ADDENDUM NO. 2

**LIFT STATION NO. 7 REPAIRS
PROJECT NO. 2011-S-1**

CITY OF GRAND ISLAND, NEBRASKA

RE: Addendum to expand bidding alternative in Arthur and Grant
repair method.

ARTHUR TO GRANT
OPTION NO. 2

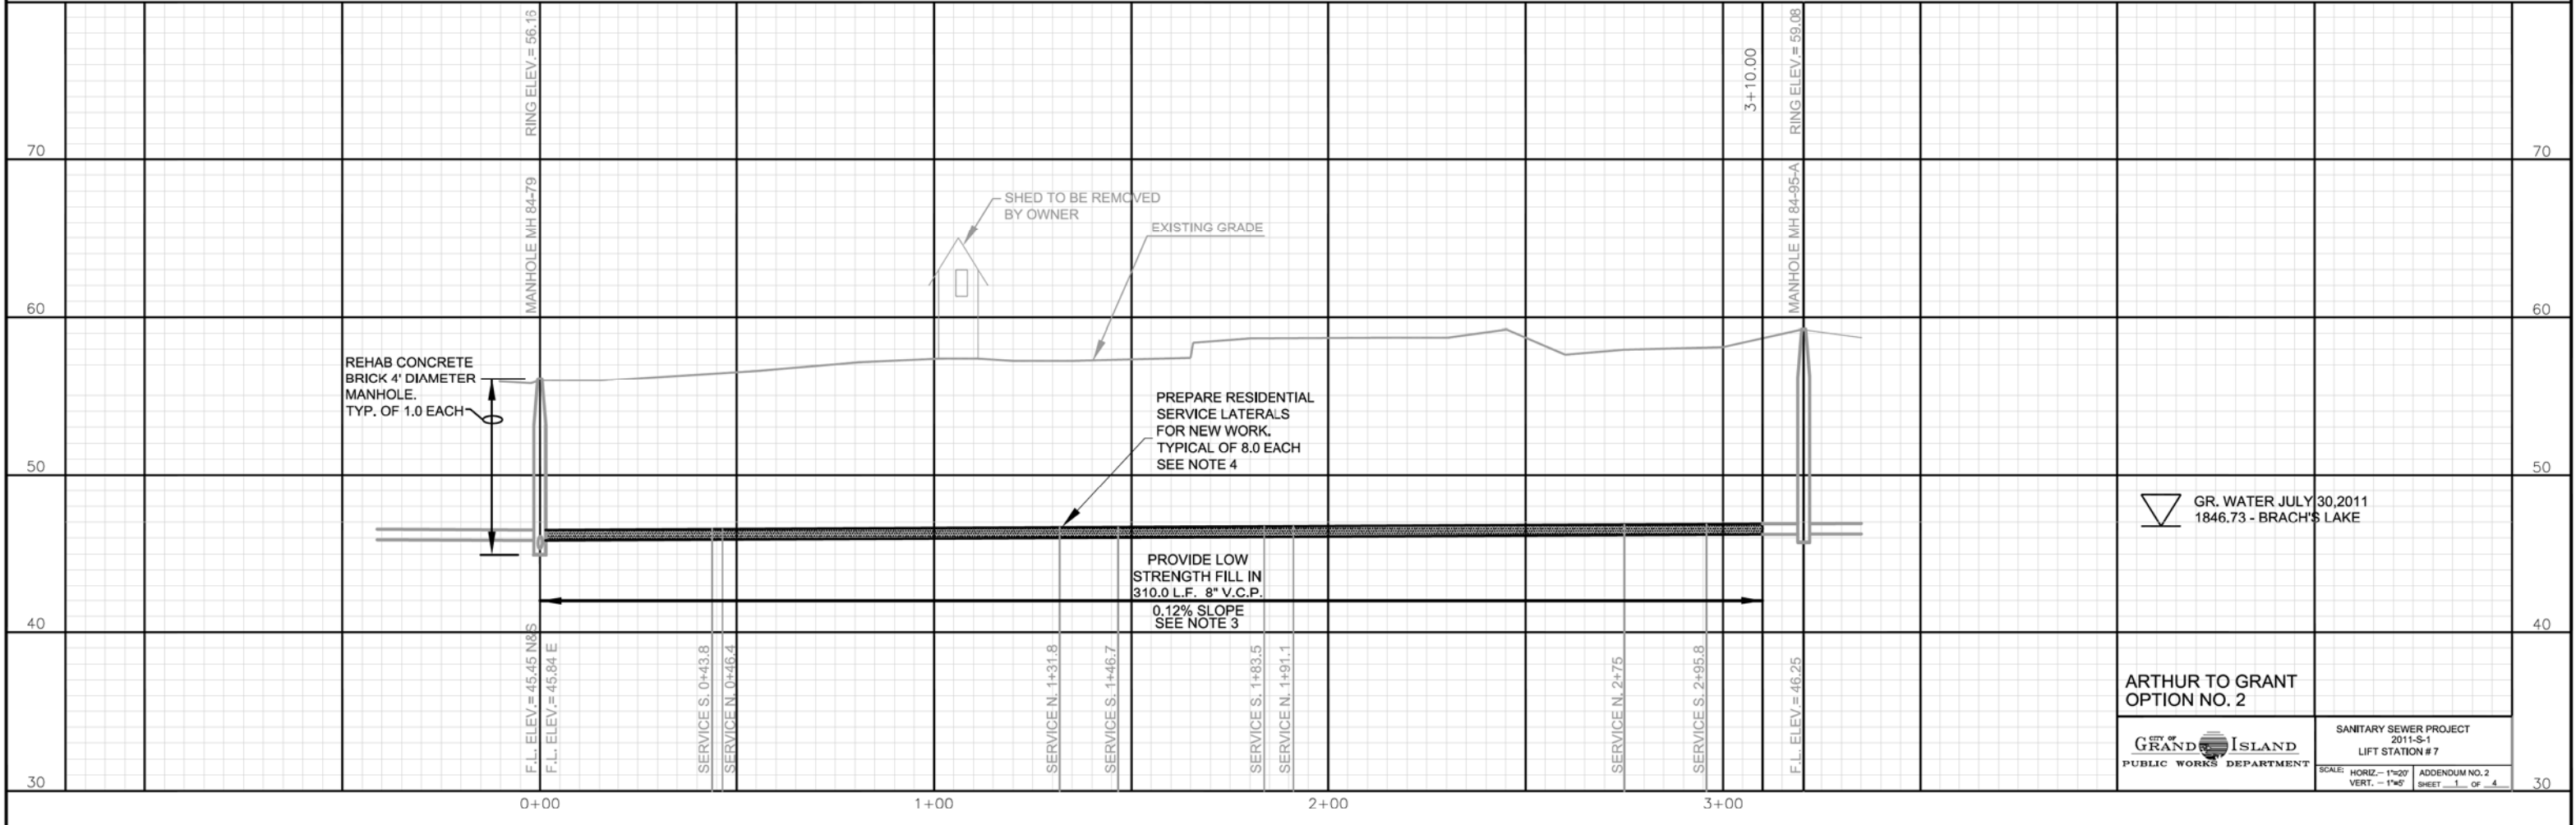
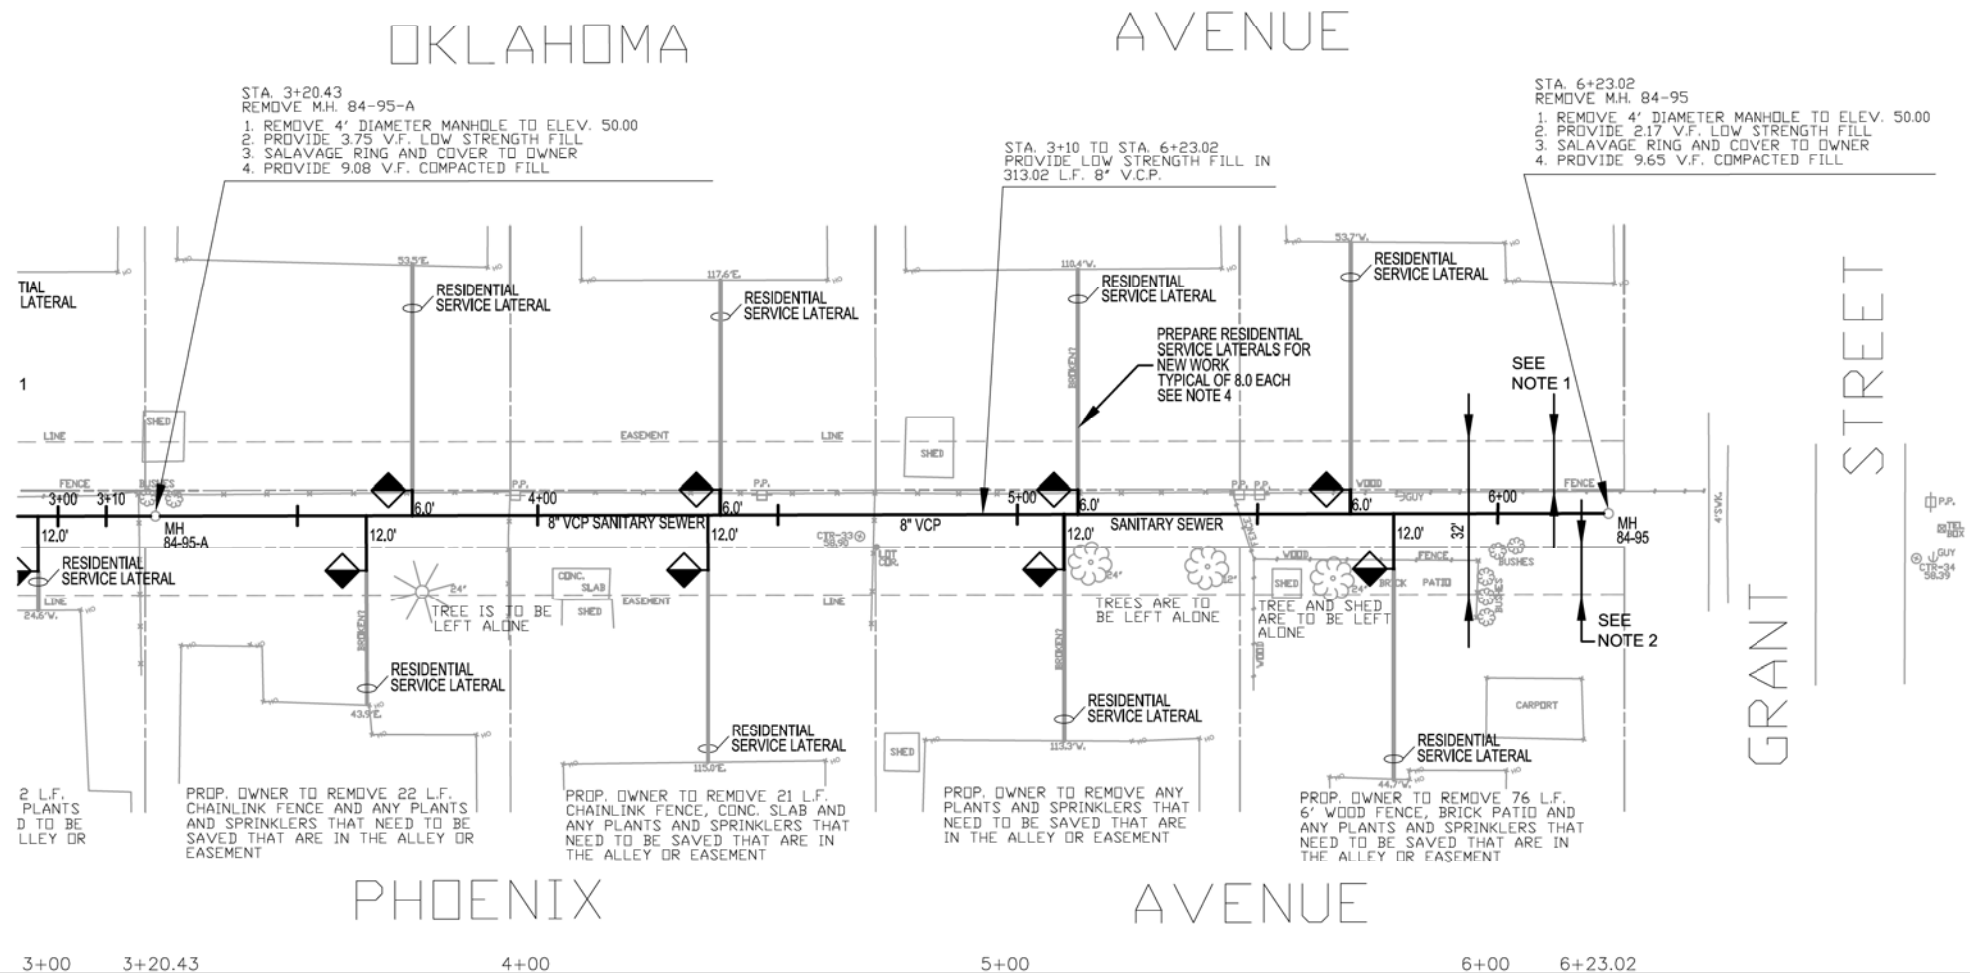
- STA. 0+00
REHAB M.H. 84-79
1. MOBILIZATION 1 EACH
 2. REMOVE STEPS 4 EACH
 3. INFILTRATION LEAK M.H. SIDEWALL 1 EACH
 4. INFILTRATION LEAK BENCH & INVERT 1 EACH
 5. M.H. REHAB 4' DIA. CEMENTITIOUS LINING 10.71 V.F.
 6. M.H. REHAB 4' DIA. EPOXY LINING 10.71 V.F.

STA. 0+00 TO STA. 3+10
PROVIDE LOW STRENGTH FILL IN
310 L.F. 8" V.C.P.

1. 10' NORTH CONSTRUCTION EASEMENT, OBTAIN ENGINEER AUTHORIZATION PRIOR TO ENTRANCE.
2. 10' SOUTH CONSTRUCTION EASEMENT.
3. LOW STRENGTH FILL SHALL CONFORM TO NEBRASKA DEPARTMENT OF ROADS (NDOR) STANDARD SPECIFICATIONS; DIVISION 1000, MATERIAL DETAILS; 1003 FLOWABLE FILL.
4. POT HOLE EXISTING LATERALS AT LIMITS OF CONSTRUCTION. DOCUMENT TOP OF PIPE ELEVATION, MATERIAL OF CONSTRUCTION, AND SIZE OF SERVICE. PROVIDE RECORDS TO ENGINEER PRIOR TO NEW CONSTRUCTION WORK.
5. ALLOW ABANDONED SERVICE LATERALS TO VENT IN LOW STRENGTH FILL APPLICATION. SAND FILL ALL VOIDS.

ADDENDUM NO. 2
SHEET 3 OF 4

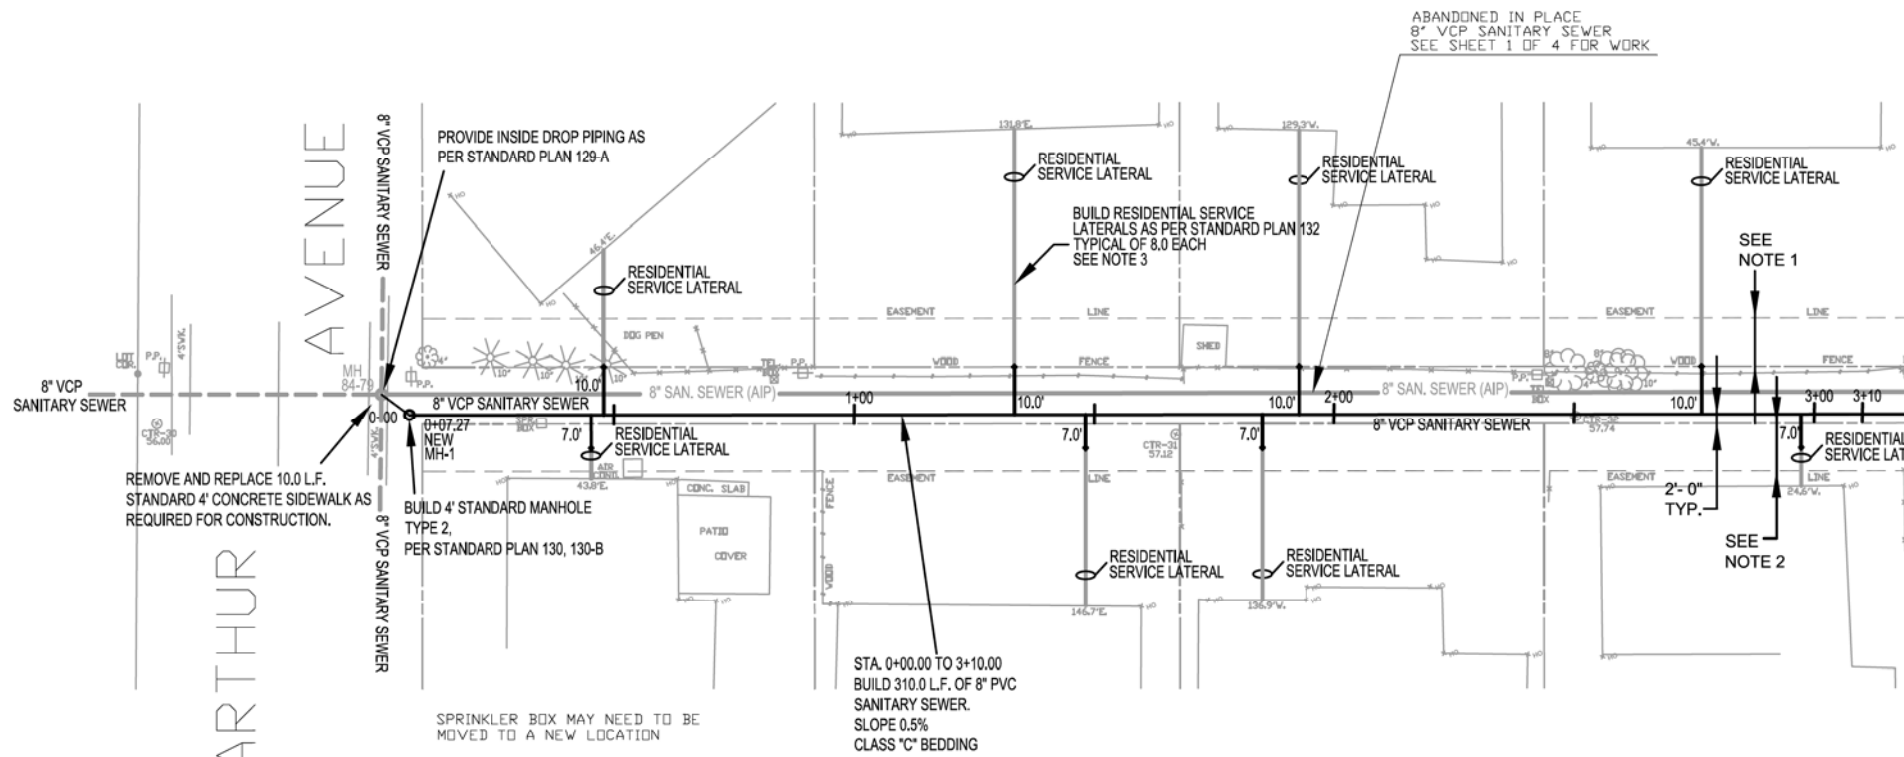
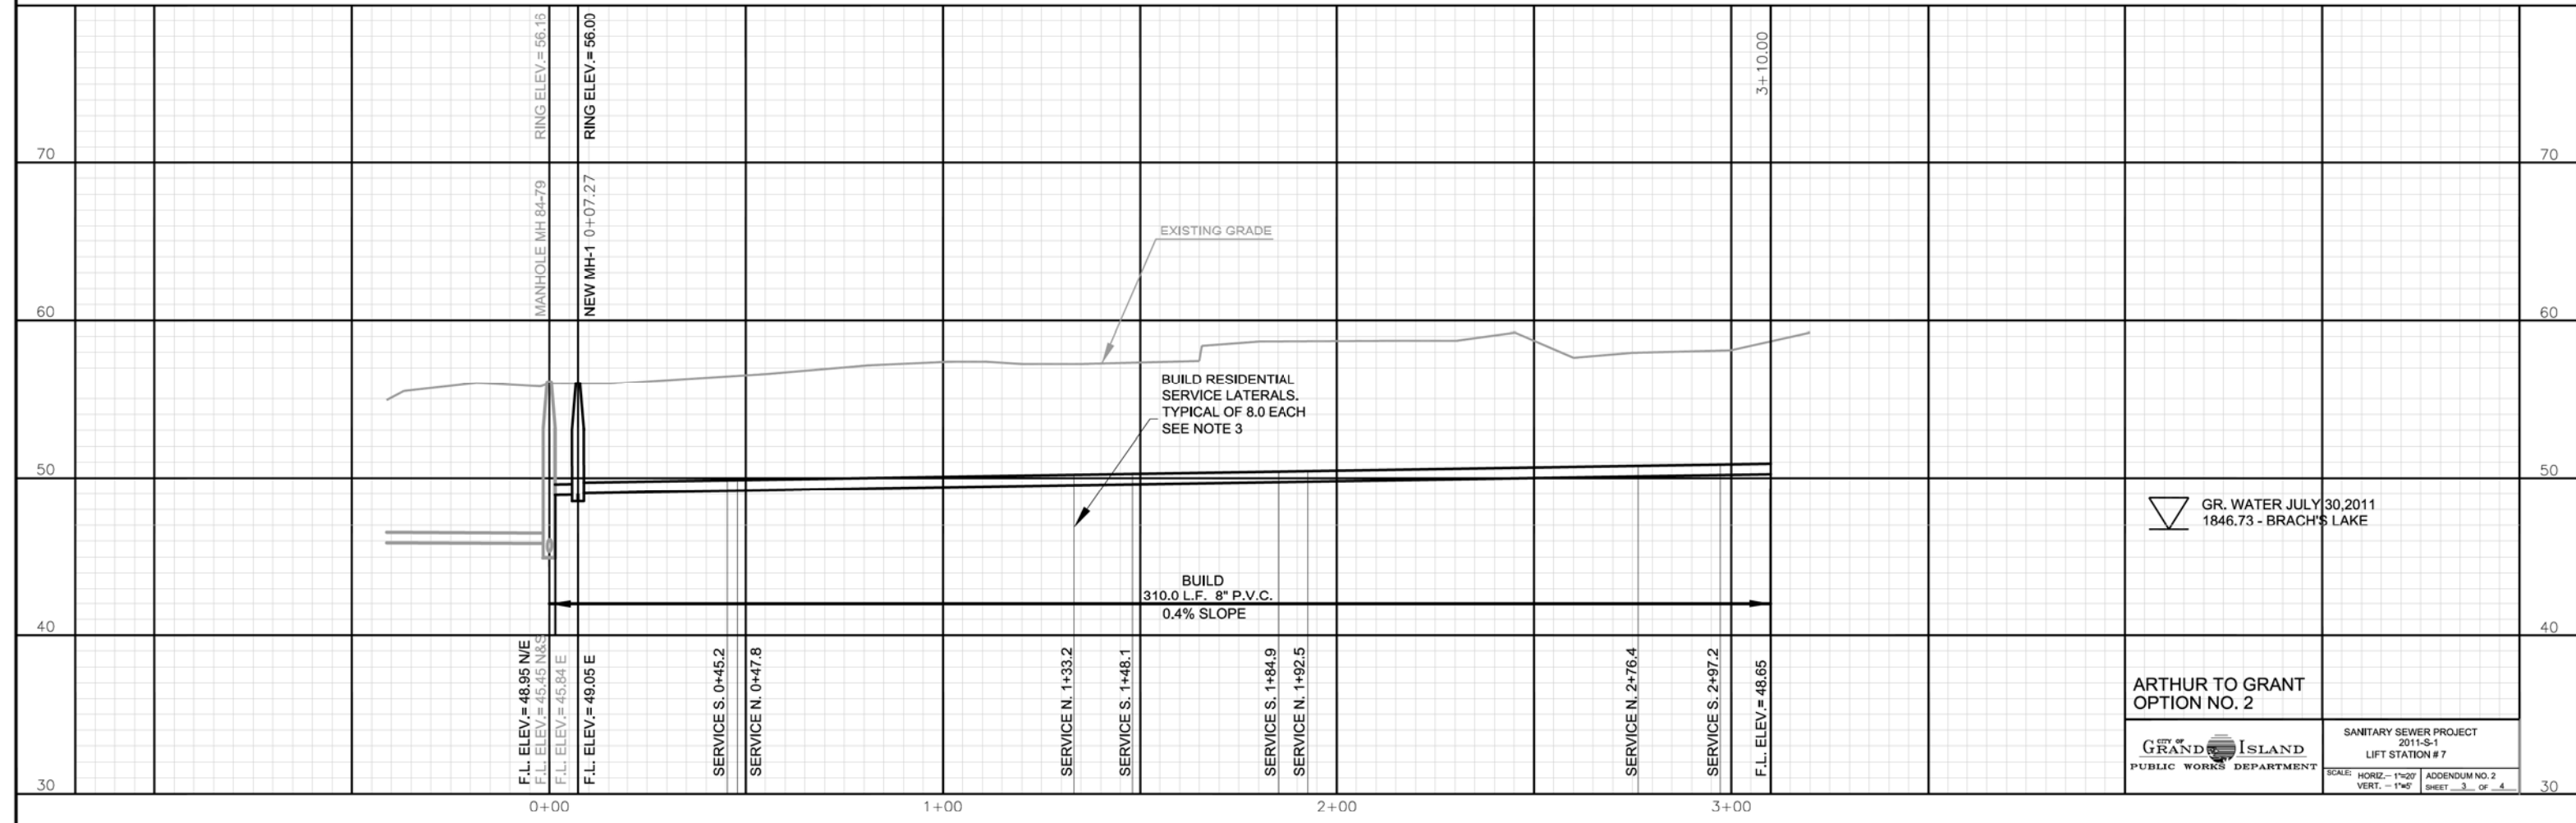
- 10' NORTH CONSTRUCTION EASEMENT, OBTAIN ENGINEER AUTHORIZATION PRIOR TO ENTRANCE.
- 10' SOUTH CONSTRUCTION EASEMENT.
- RESIDENTIAL SERVICE LATERAL UNIT SHALL COMPOSE OF MAIN LINE TEE CONNECTION, HORIZONTAL LENGTH (SHOWN ON PLANS), VERTICAL LENGTH (CONTRACTOR CONFIRMED), TWO (2) ANGLED FITTINGS, AND COUPLING.
